Technical Journal

TITLE:
**No or intermittent unlocking function from door handles
(S60 w/ Keyless drive)**

REF NO: TJ 26520	ISSUING DEPARTMENT: Technical Service	CAR MARKET: United States and Canada		
PARTNER: 3 US 7510 Volvo Cars North America		ISSUE DATE:		
FUNC GROUP: 8340	FUNC DESC: Lock, handle	YEAR 2014	MONTH 03	DAY 04
Page 1 of 5

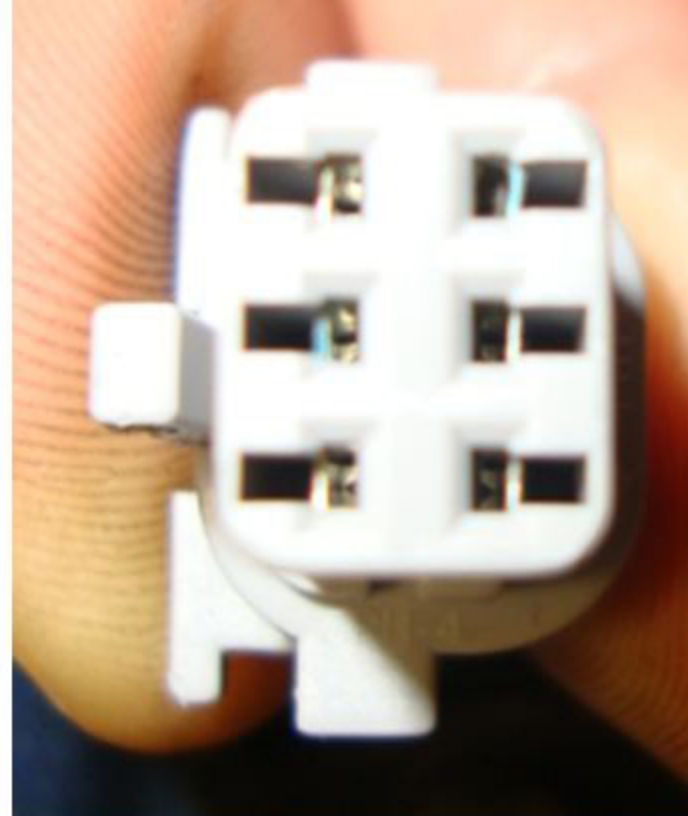
Notes for when corrosion is found:

See Corrosion.JPG .

If corrosion is found, the door handle must also be replaced, as it is likely that the corrosion was caused by water leakage through the handle. See TJ 27787 for instructions on reusing painted outer door handle covers.

If the corrosion has extended deep enough into the harness that the copper is discolored at the location where the splices would be made, the harness cannot be properly repaired with the extension cables; the entire door harness must be replaced.

1: Front Door

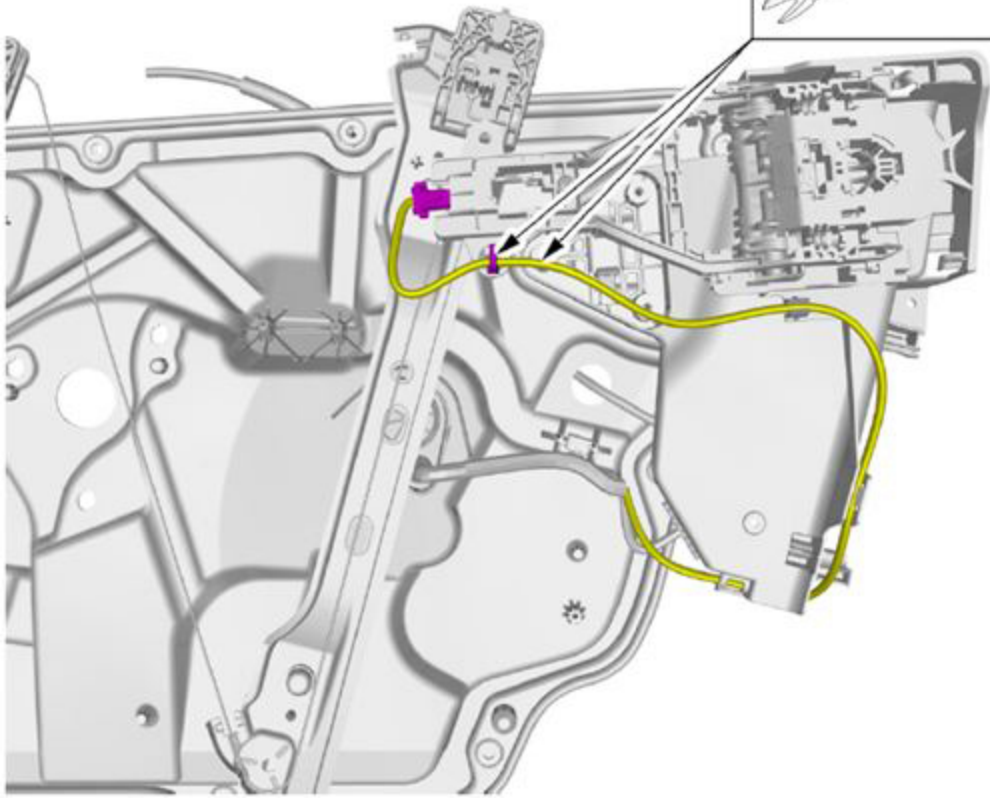
Remove the inner door panel, repair the harness and ensure the routing is as shown in Harness_Routing.JPG .

Cut the wiring length of the extension cable to correctly match the vehicle.
